UNITED STATES PATENT AND TRADEMARK OFFICE

APPLICATION NO.	FILING DATE	FIRST NAMED INVENTOR	ATTORNEY DOCKET NO.	CONFIRMATION NO.
10/824,507	04/14/2004	James M. Chwalek	83330WRZ	6458

Office Action Summary	Application No. 10/824,507	Applicant(s) CHWALEK ET AL.	
	Examiner Laura E. Martin	Art Unit 2853

DETAILED ACTION

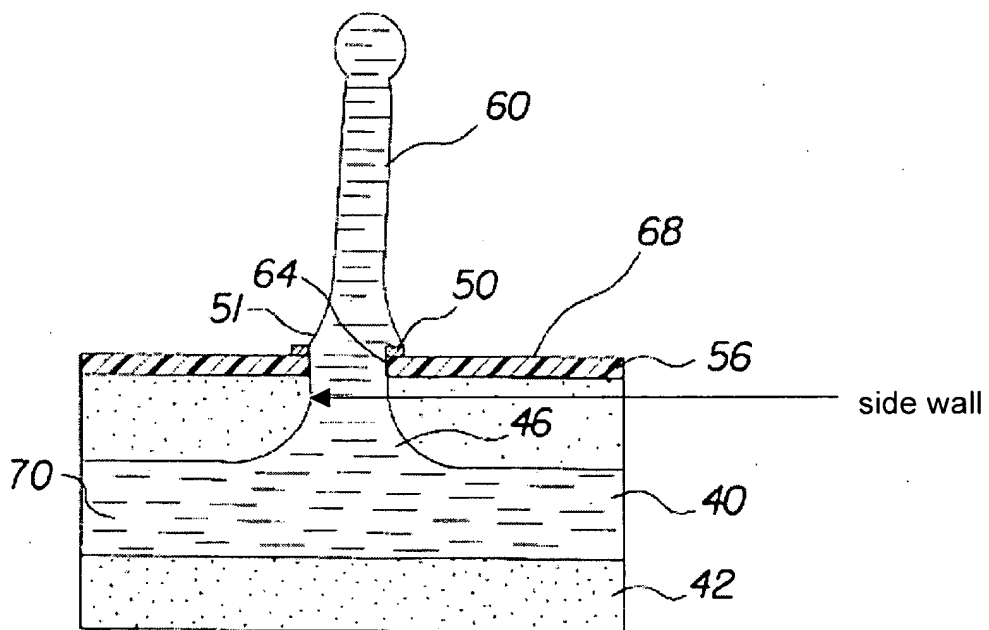
As per claim 6, Anagnostopoulos et al. teaches a printhead, wherein the fluid drop steering device is a heater (figure 2A, element 50) operatively associated with the fluid chamber (figure 2A, element 46).

As per claim 7, Anagnostopoulos et al. teaches a printhead, the fluid chamber having a side wall (shown below), wherein the heater is formed as a portion of the side wall (figure 2A, element 50).

As per claim 10, Anagnostopoulos et al. teaches the chamber having a side wall (shown above), wherein the heater is located adjacent to the side wall (figure 2A, element 50).
